Re: Road Modification/Waiver Request –  
Meadowsweet Preliminary Plan /  
Site Plan Application  
RCI Job No. 377-K3

**Meadowsweet (Farquhar) Property**  
**Concurrent Preliminary and Site Plan Application**  
**Identification of Subdivision/Zoning Waivers and Justification Statement**

**Project Description and Justification Statement for Waivers or Variance of Zoning or Subdivision Standards (MNCP&PC Preliminary Plan Checklist item 1.4)**

STANDARD NO. MC-222.02

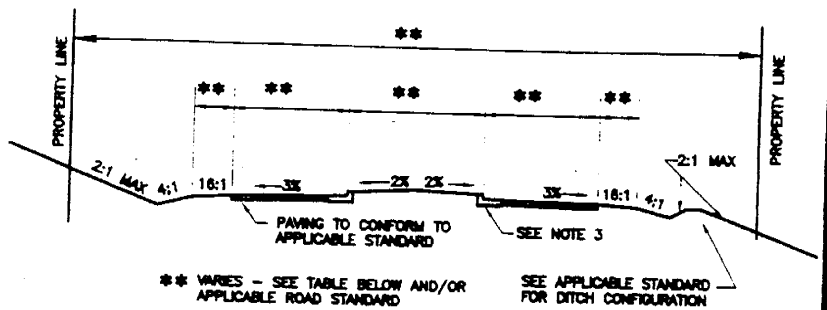
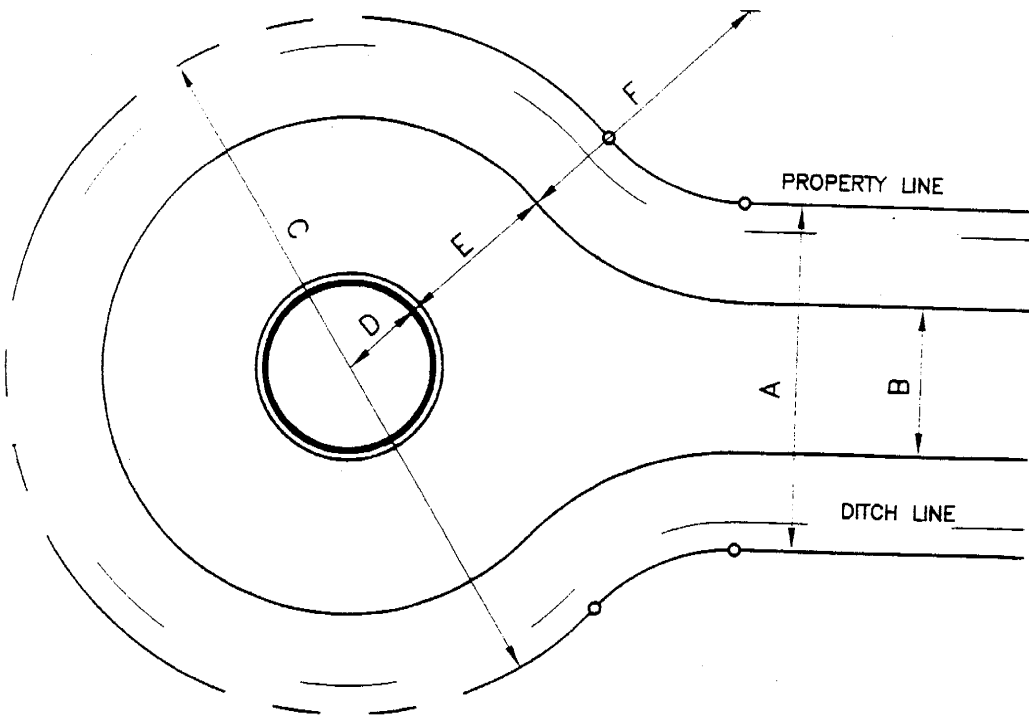
In order to provide a central green consistent with the zoning requirements for 'common open space', the applicant is proposing a modification to the design standards for an open section cul-de-sac (Std. No. MC-222.02). The island of the cul-de-sac has been expanded significantly in order to provide enough green area within the island to allow for sitting areas, pathways and informal landscape treatments. The minimum outside turning radius for a cul-de-sac of 40 feet has been maintained.

The applicant is also requesting approval of a modification to the typical cross-section of Meadowsweet Drive and Meadowsweet Court. The proposed modification will increase the PUE from 8 feet to 10 feet as requested by the utility companies during the pre-preliminary review of this property.

This request is justified and appropriate in that it provides a central open space to the plan as required in the RNC zone, while at the same time maintains minimum turning movements as required by the subdivision regulations and Montgomery County road design criteria.
